PRAIRIE ISLAND NUCLEAR GENERATING PLANT  
Docket Nos. 50-282 License Nos. DPR-42  
50-306 DPR-60

Response to Request for Additional Information Related  
to Containment Purge and Vent System Isolation Valves

PRAIRIE ISLAND NUCLEAR GENERATING PLANT  
INFORMATION REQUIRED FOR CONTAINMENT PURGE  
AND VENT VALVE LONG-TERM NRC STAFF REVIEW

FIGURE 1

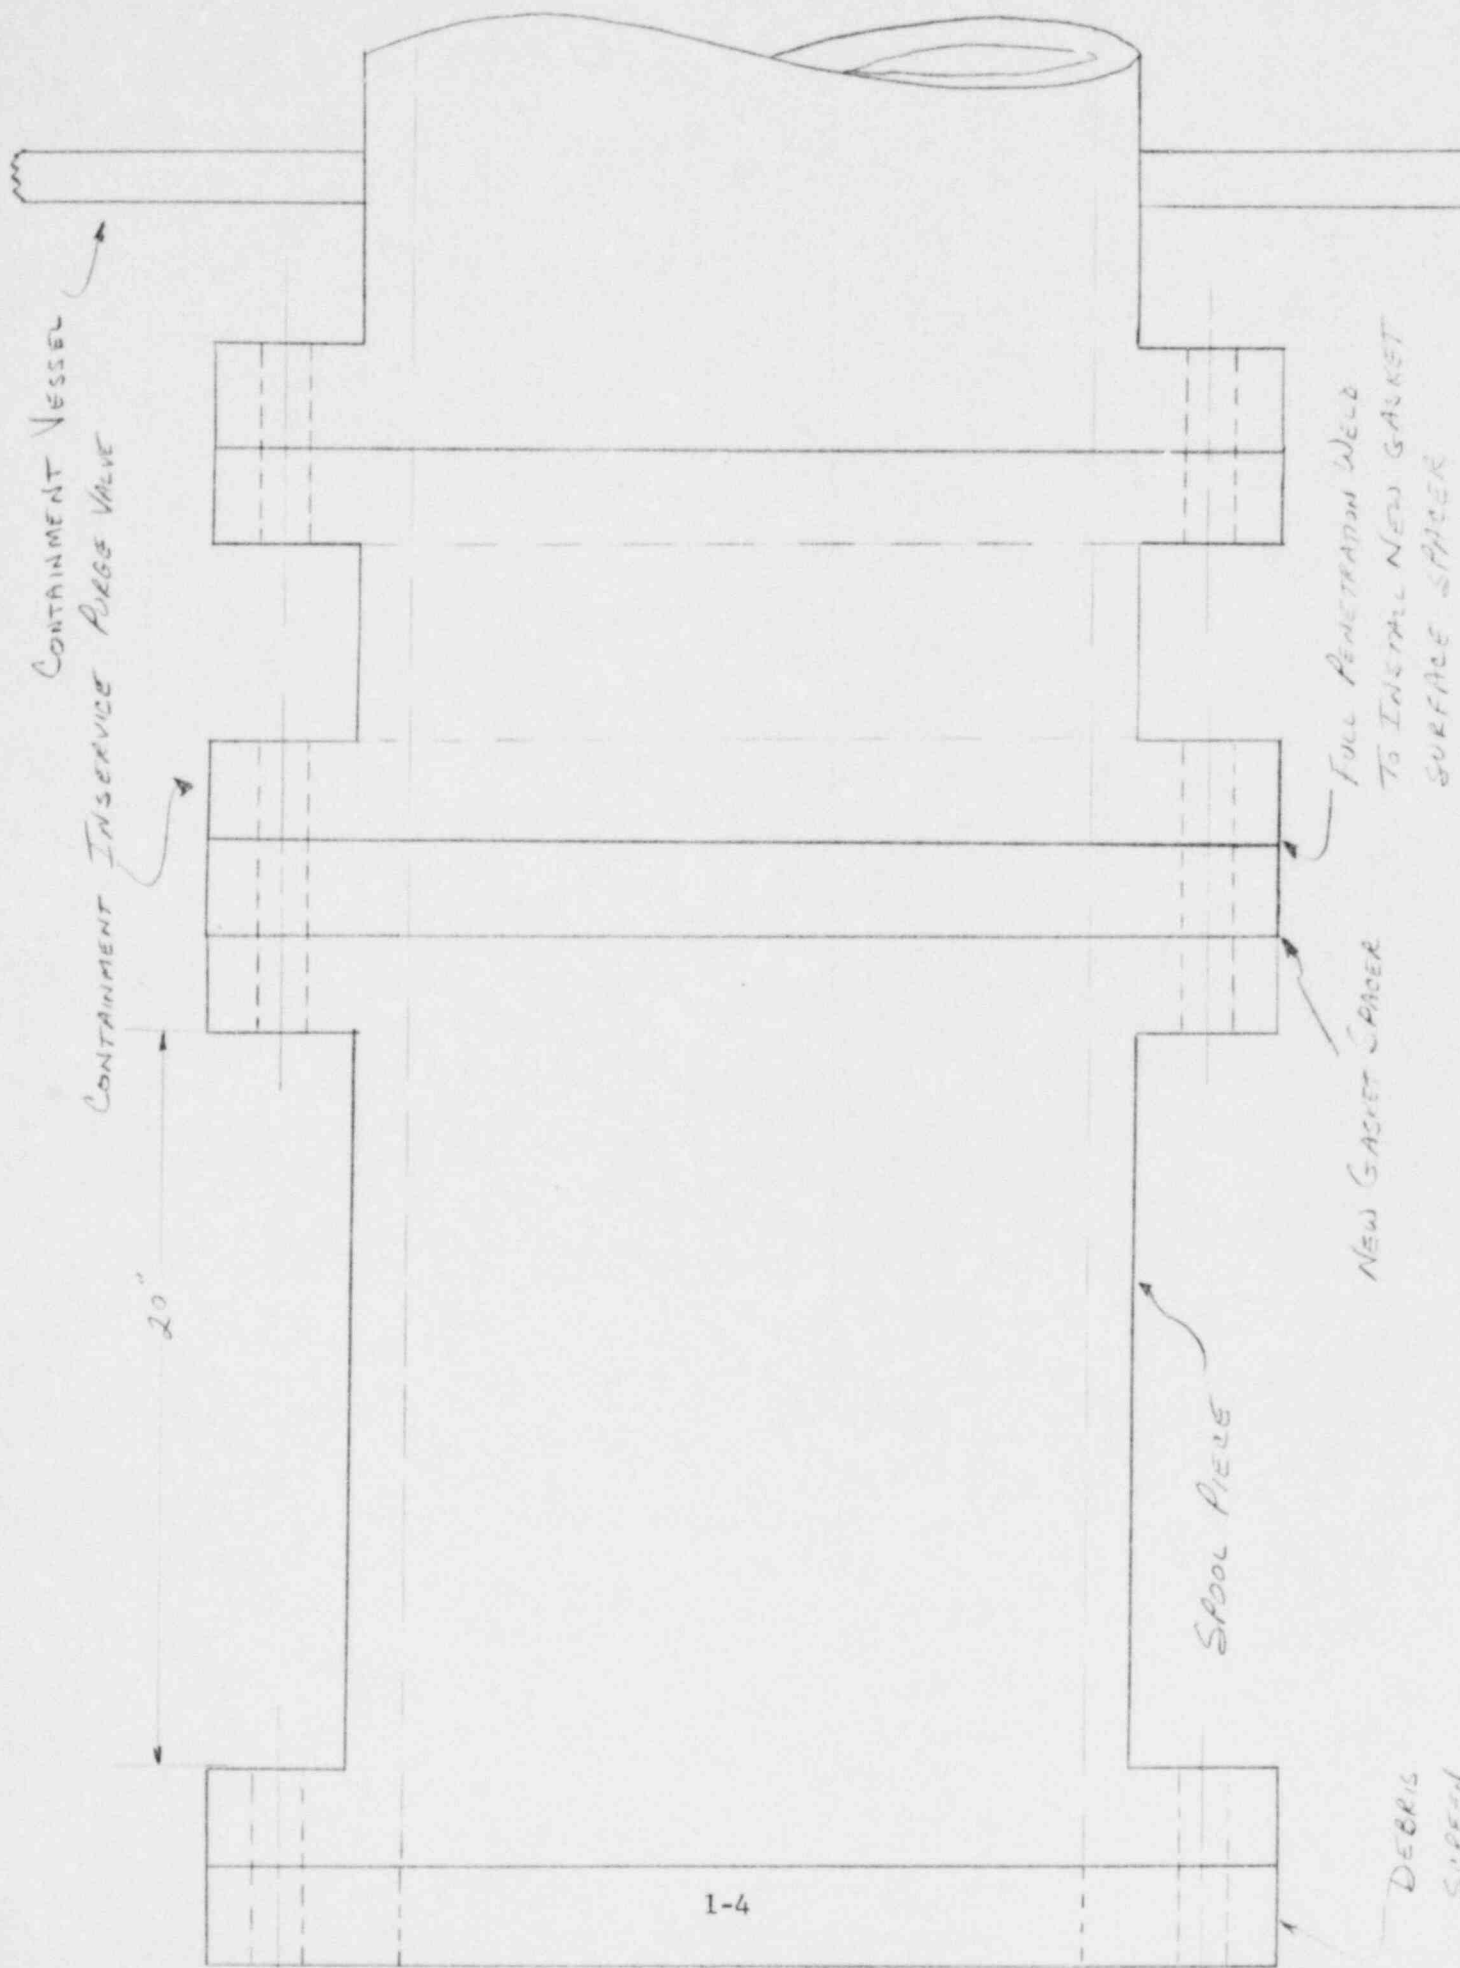
- (a) Commit to the installation of debris screens in the purge supply and exhaust lines that meet the requirements described in Enclosure 2. You are also requested to provide an installation schedule for the debris screens for Units 1 and 2.

- 1(a) Debris screens will be installed in each 18-inch containment purge and vent line whenever the system is in use. The debris screens will be designed in accordance with the guidelines provided in Enclosure (2) to Mr Clark's March 8, 1982 letter. Refer to Figure (1).

The 36-inch purge and vent system penetrations for each unit will be sealed off with double-gasketed covers when the associated unit is above cold shutdown. The system will only be used during outages. Debris screens will not be required.
